## ADDENDUM No. 2

ITB No. 4477

### Street Resurfacing - 2017

The following changes, additions, and/or deletions shall be made to the Invitation to Bid for Street Resurfacing - 2017, ITB No. 4477, on which proposals will be received on/or before March 30, 2017, at 10:00 A.M. (local time).

**INTEGRAL SIDEWALK RETAINING WALL (18"-36") DETAIL**

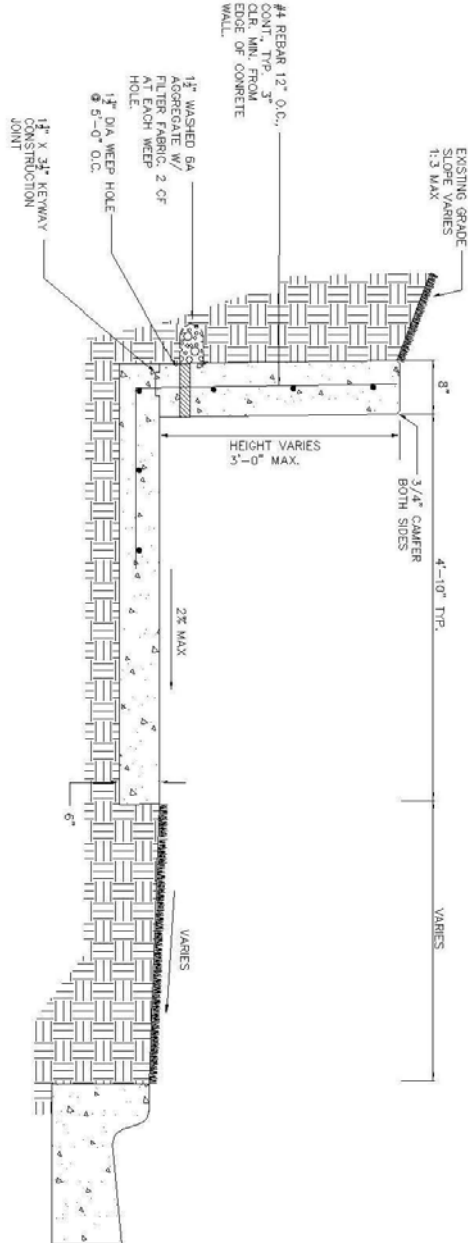
- Item #11: Detailed Specification for Sidewalk Retaining Walls pages DS-53 and DS-55; replace with attached pages Addendum-2-27 and Addendum-2-30.
- Item #12: Insert Detailed Specification for Cast Iron Detectable Warning Surface page Addendum-2-31.
